SERVICE BULLETIN

SB1365

ADDRESSEES	: Owners and operators of coaches mentioned under "Application"
VEHICLE MODEL	: C2045, CX35, CX45, TX45
MANUAL CHAPTER	: 02.22 Traction engine – Air intake system
BULLETIN TYPE	: Field Change Program
DATE	: June 17th, 2016
SUBJECT	: To check engine air-intake pipe for interference damage
TERMS & CONDITIONS	: Refer to the warranty section further in this Bulletin.

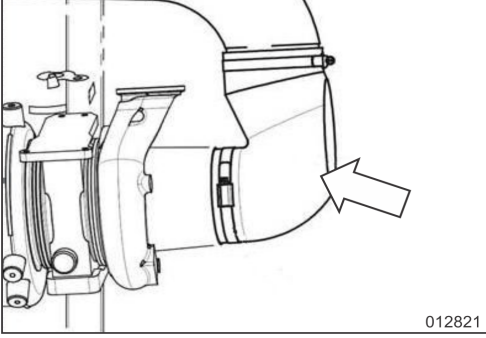
Step	Action
1	<p>Open the exterior access door of the radiator compartment, located on the left very rear side. Remove the screws and take the side panel away to get access to the air-intake pipe between the air-cleaner and the turbocharger.</p> <div data-bbox="571 1563 1182 1982" data-label="Image"></div> <p>Figure 1</p>
